August 24, 2023

Re: Docket No. 508 - The United Illuminating Company Application for a Certificate of Environmental Compatibility and Public Need for the Milvon to West River Railroad Transmission Line 115-kV Rebuild Project - Request for Modification to Structure Locations Near West River Substation

CROSS SECTION 12

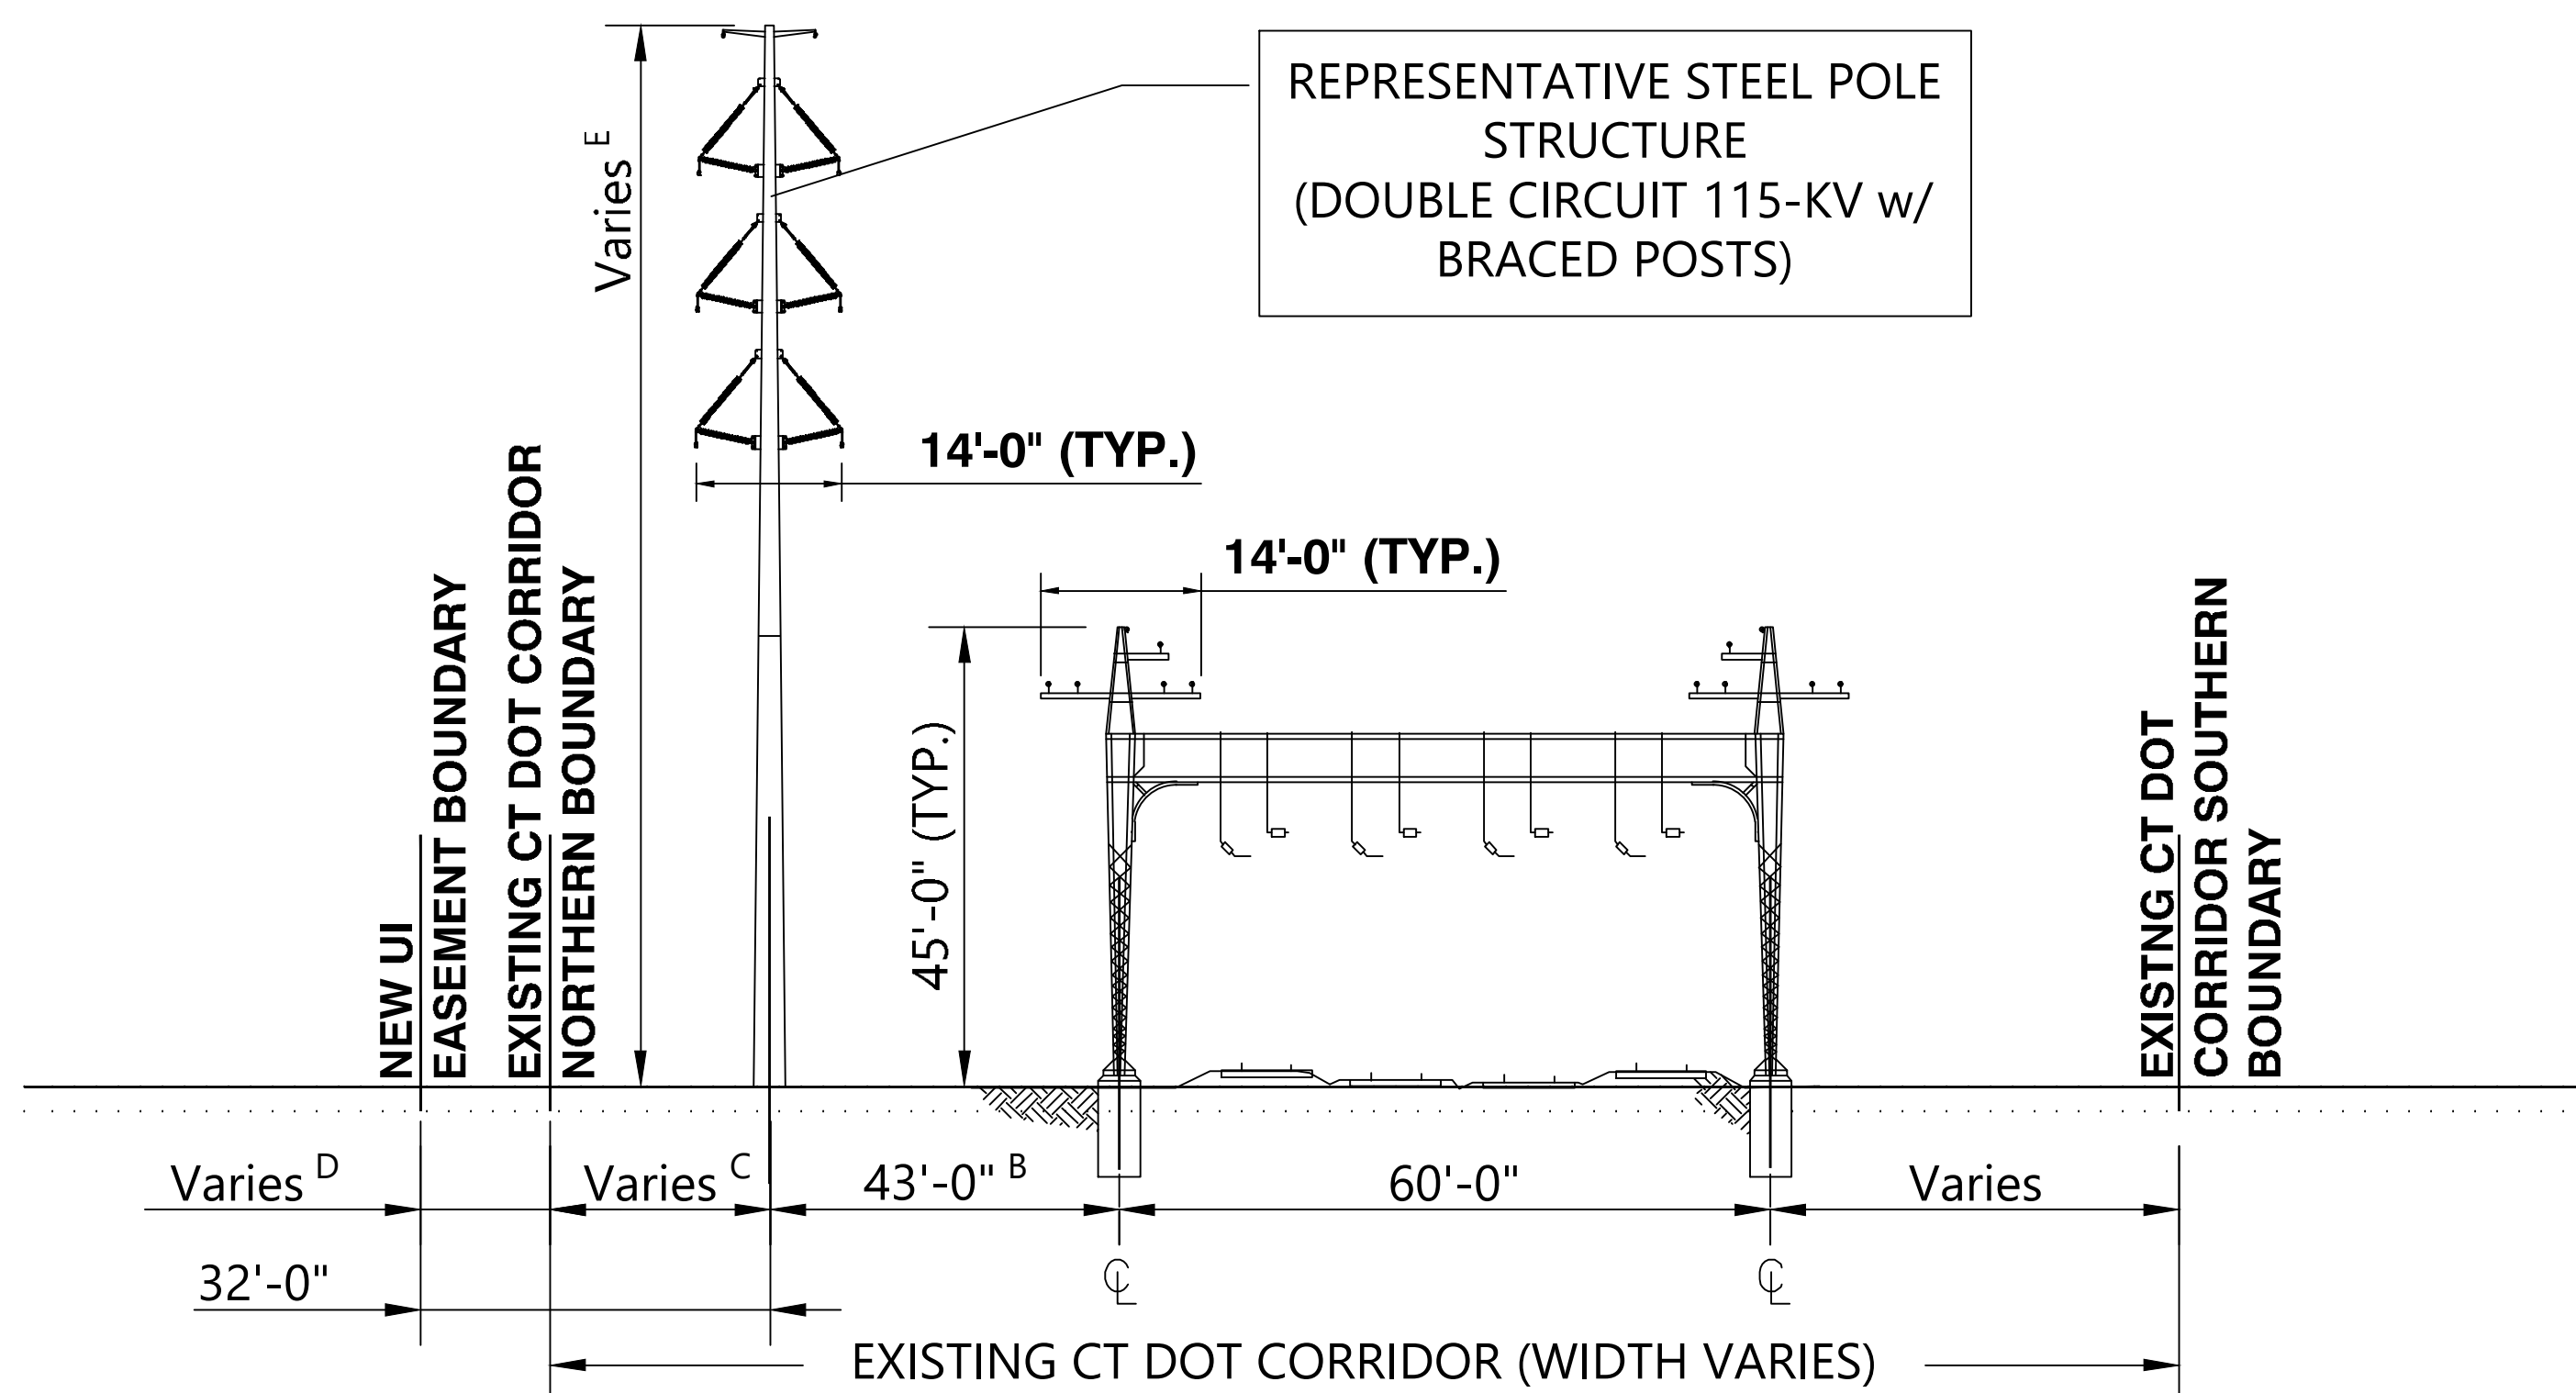
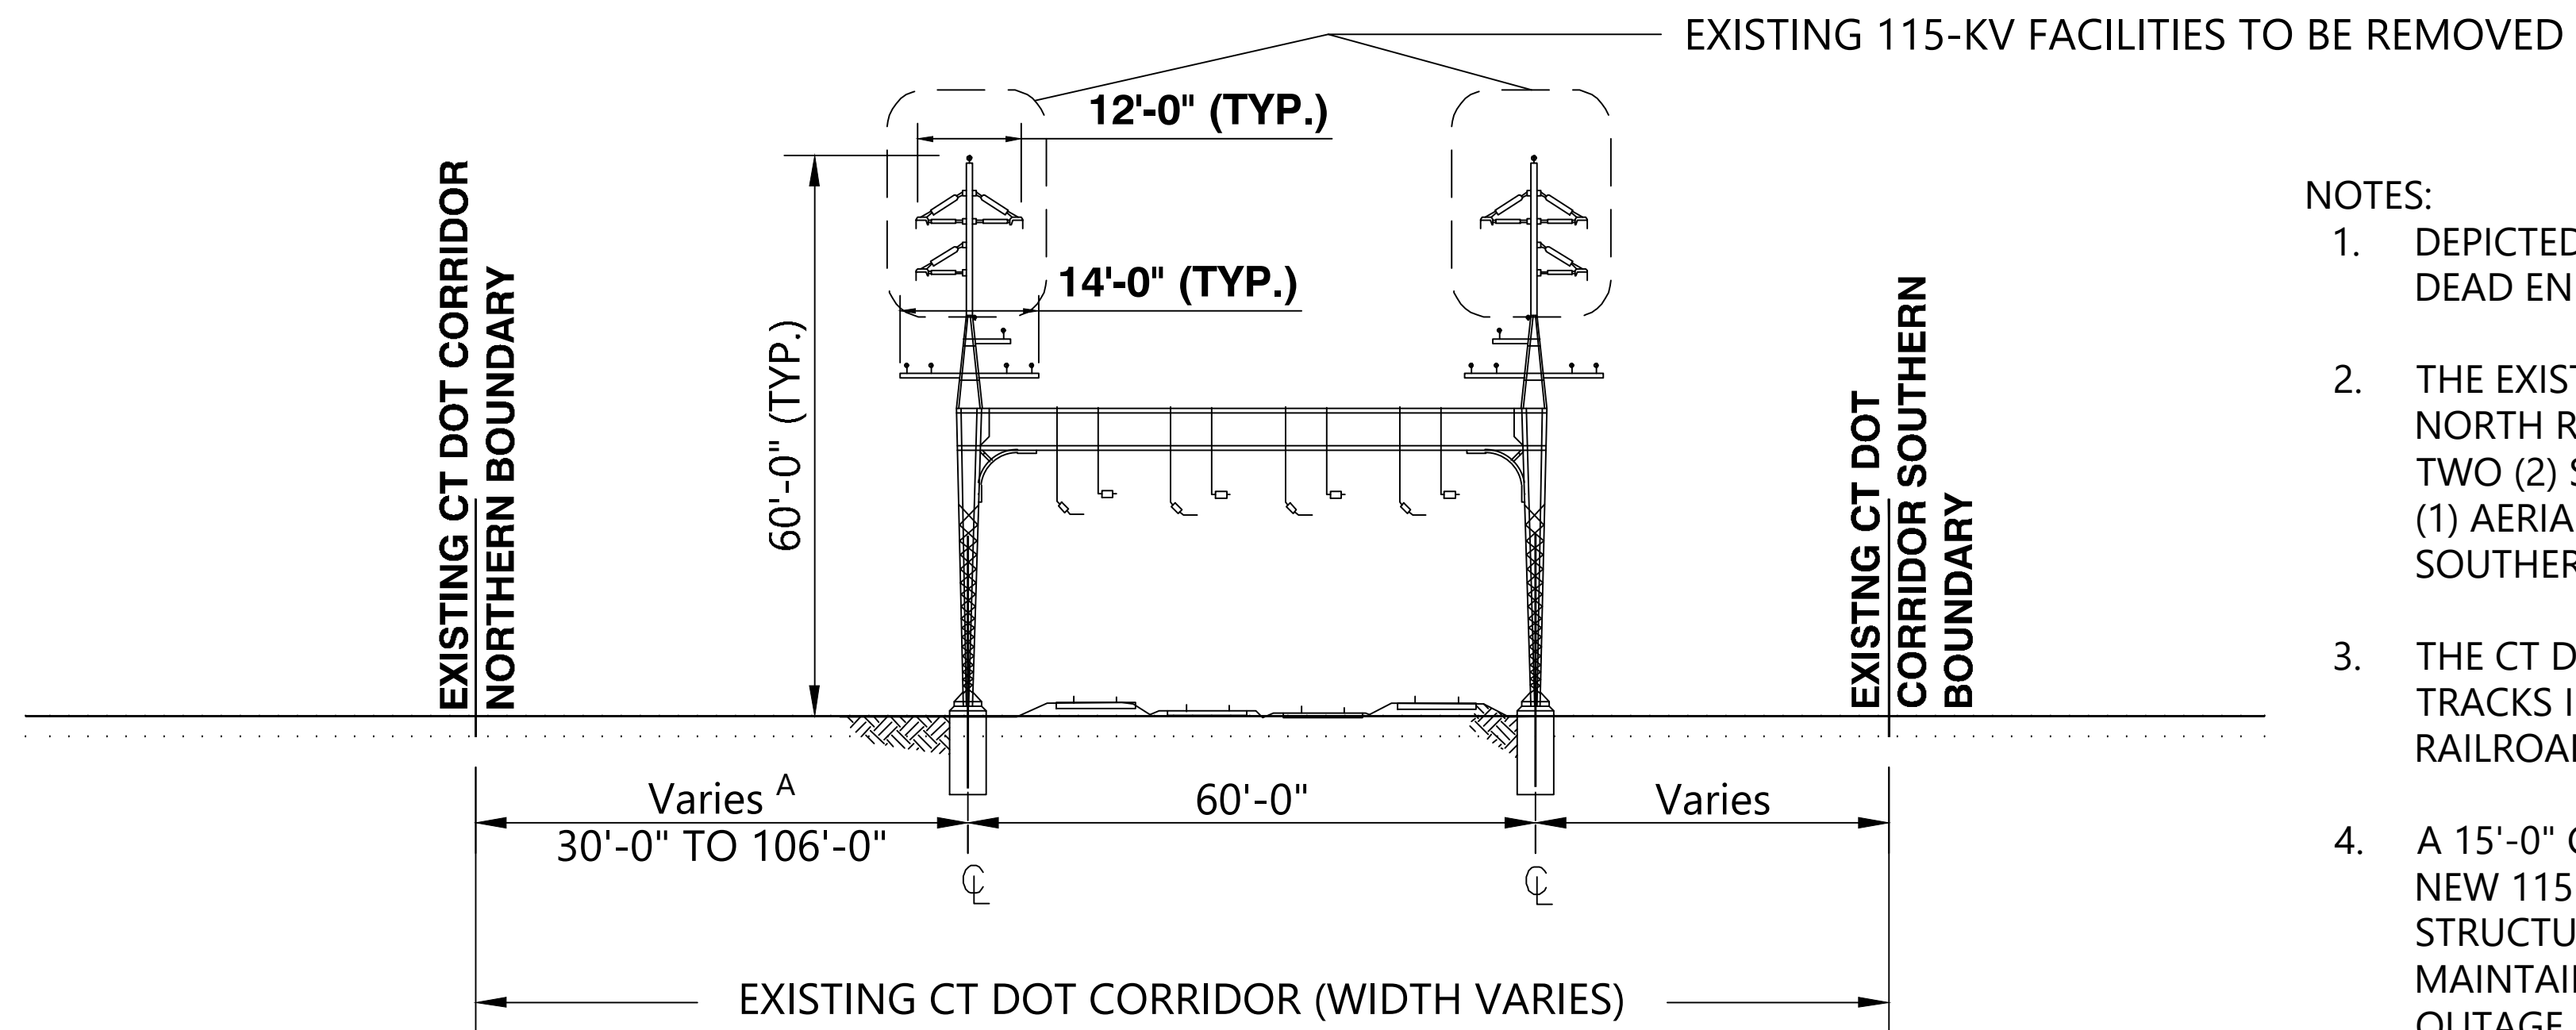
Structure No.	Pole Length (Original→Revised)	Structure Configuration (Original→Revised)	Transverse Offset* from Original Location (ft)***	Longitudinal Offset** from Original Location (ft)***
P1034N	100'→95'	Tangent w/ Braced Posts→ Deadend w/ Davit Arms	0	0
P1035N	95'→125'	Tangent w/ Braced Posts→ Tangent w/ Braced Posts	20	52
P1036N		Removed		
P1037N	95'→120'	Deadend w/ Davit Arms →Deadend w/ Davit Arms	47	33
P1038N	125'→125'	Tangent w/ Braced Posts→ Tangent w/ Braced Posts	0	35

- One of the double circuit steel monopoles originally planned for location along the north side of the MNR tracks in West Haven will be eliminated.
- Structures P1035N and P1037N will increase in height (to 120 and 125 feet, respectively) because of increased span length due to the elimination of P1036N and to maintain required vertical clearances for an adjacent building. These two structures were shifted farther north to accommodate the future planned spur tracks and work areas for MNR and CDOT.
- The realignment of P1035N and P1037N to the northern edge of the CDOT property will require easements on adjacent private properties, which will result in an additional 0.34 acre of permanent easements for the Project.

REV.	DATE	BY	DESCRIPTION	APP.	DATE:
0-0B	2023/07/31	WESTWOOD	SEGMENT 1 D&M PLAN UPDATED AT WEST HAVEN LUMBER YARD	DR: SFB	SCALE AS SHOWN FILE:
0-0A	2023/04/03	WESTWOOD	SEGMENT 1 D&M PLAN FOR CSC REVIEW	CK: JRD	NO.
				APP: MSP	XS 1 OF 3
